Fernald Closure Project
Letter No. C:BSOP(CA/PC):2006-0047

CONTRACT DE-AC24-01OH20115, SUBMISSION OF THE FINAL REMEDIAL ACTION REPORT FOR OPERABLE UNIT 2 – OTHER WASTE UNITS

Response to Comments
Informal Review of the Final Remedial Action Report for OU 2
Informal Review of the Revised Final Remedial Action Report OU2
Informal Review of the Final Remedial Action Report for OU3 and the Interim Remedial
Action Report for OU5

Figure 2-1 Operable Unit 2 – Waste Units and Haul Road (Circa July 1996)

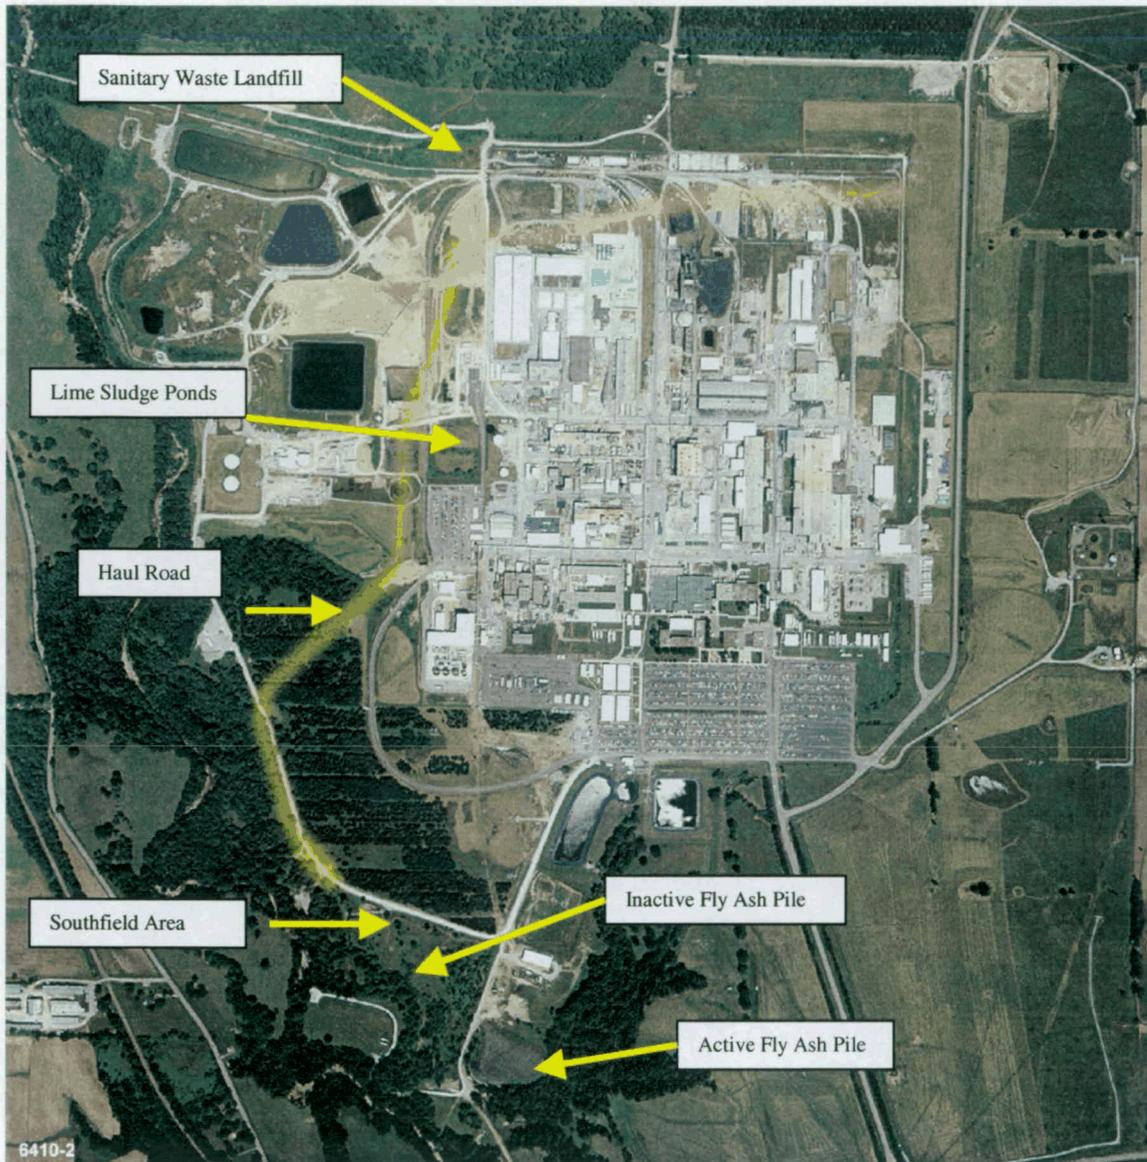
20. Commenting Organization: Ohio EPA Commentor: OFFO
Section #: 2.0 Pg. #: 6 Line #: Code: C
Comment: Include within the report a figure that clearly defines the boundaries of the operable unit at each waste unit so that it is clear what was and was not addressed in the ROD versus what is and is not addressed within this report.

21. Commenting Organization: Ohio EPA Commentor: OFFO
Section #: 2.0 Pg. #: 7 Line #: Code: C
Comment: Add the aerial graphic of a restored Fernald to this document. A transparent overlay of the future map to Figure 2-1 be a good place to help readers to envision what was there and what is there now.

Response: Figure 2-1 is a picture of the site identifying the location of the waste units. Appendix G contains before and after photos of the waste units. This provides the reader with sufficient information relative to the boundaries of the waste units. The discussion of the scope of the report (e.g. what is addressed in this report and what is discussed in other reports) has been expanded in Section 1.5 and a new Figure 1-1 has been added to the report as requested by several Commentors to better clarify what is and what is not addressed in each OU's closeout report.

Response: The graphic requested is beyond the scope of this document. A graphic as requested would not be available until after this report is formally submitted.

Figure B-2. Advanced Wastewater Treatment Plant (AWWT) Simplified Process Diagram

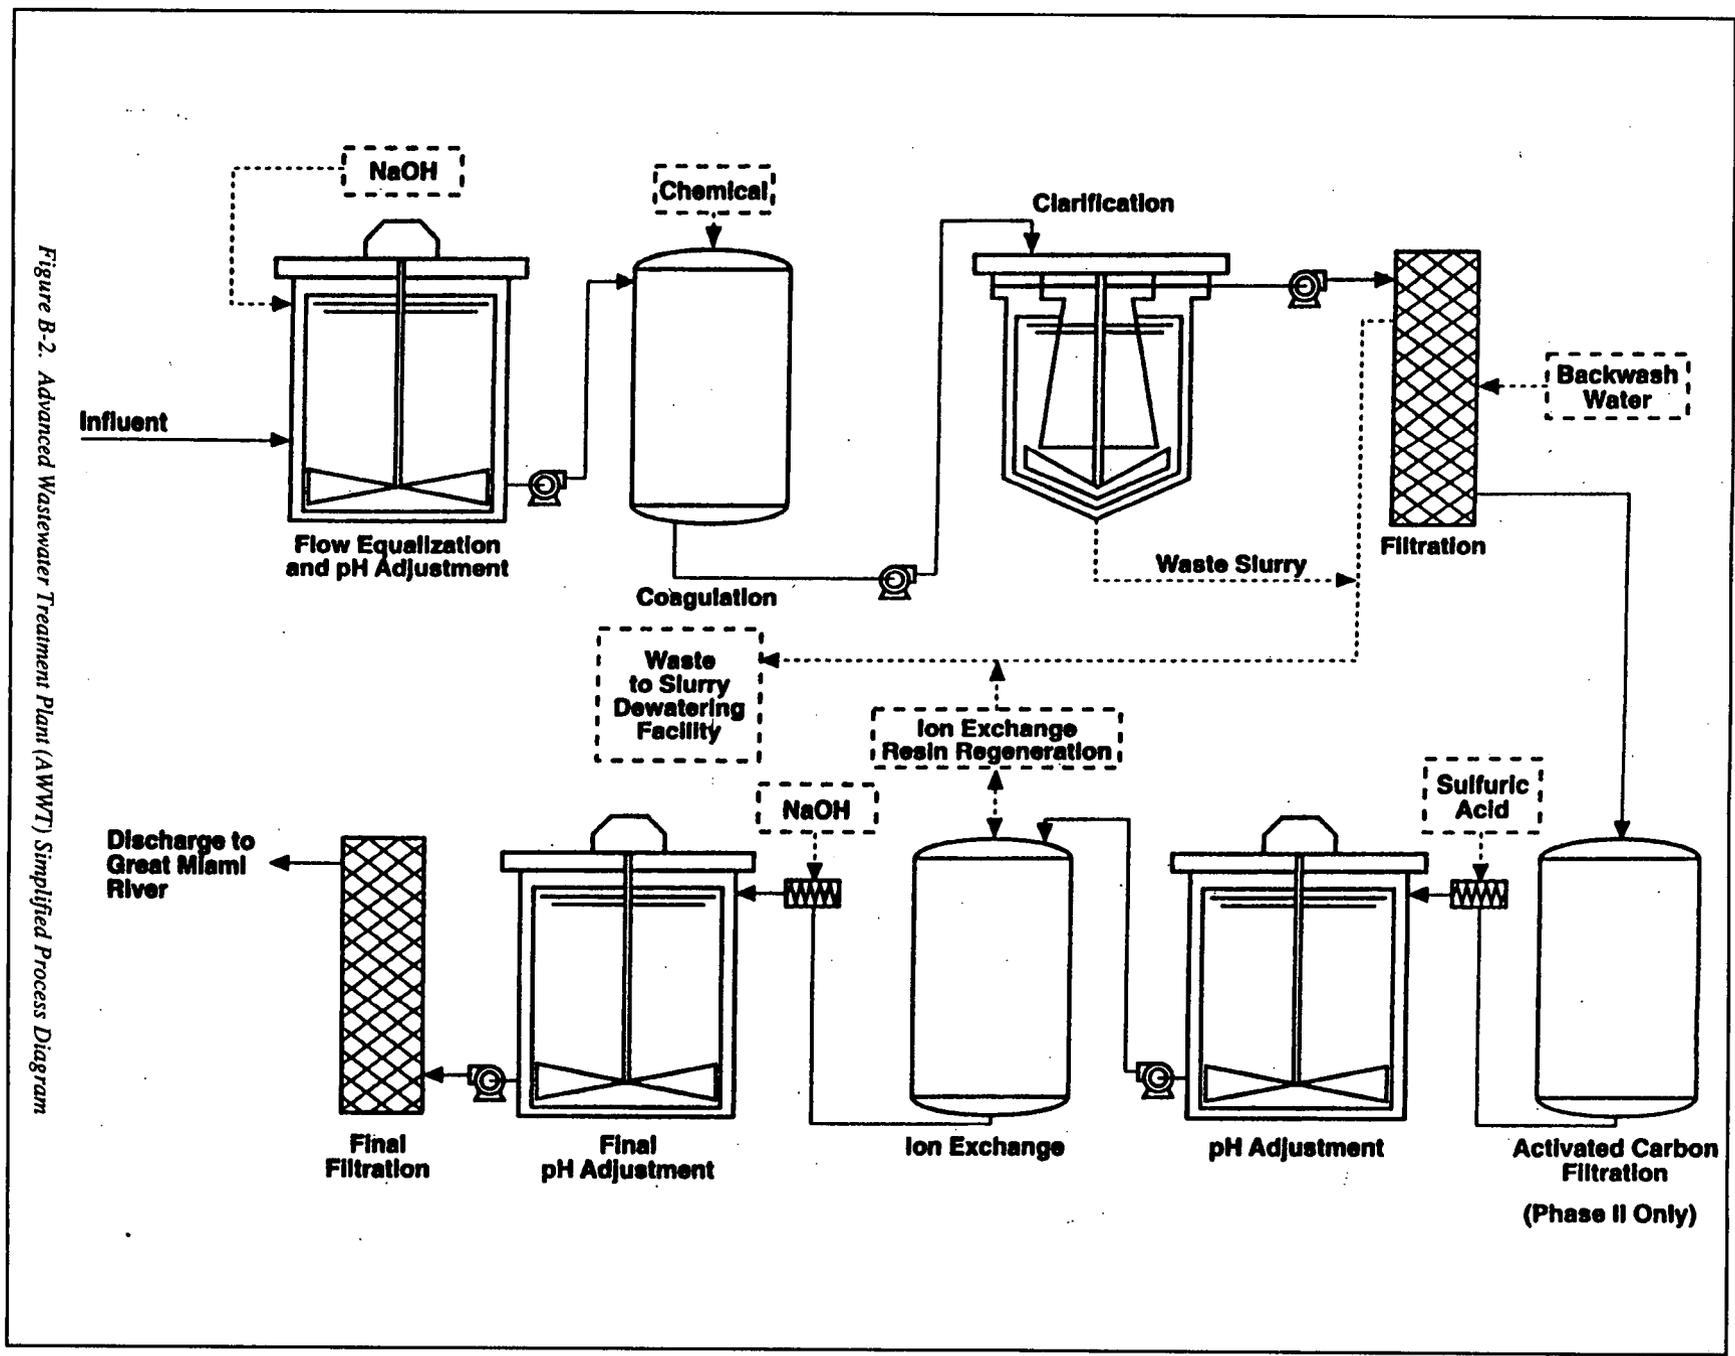
36. Commenting Organization: Ohio EPA Commentor: OFFO
Section #: Appendix B, Figure B-2 Pg. #: 26 Line #: Code: C
Comment: This figure can probably be removed. It doesn't seem necessary to explain the operation of the AWWT in this report.
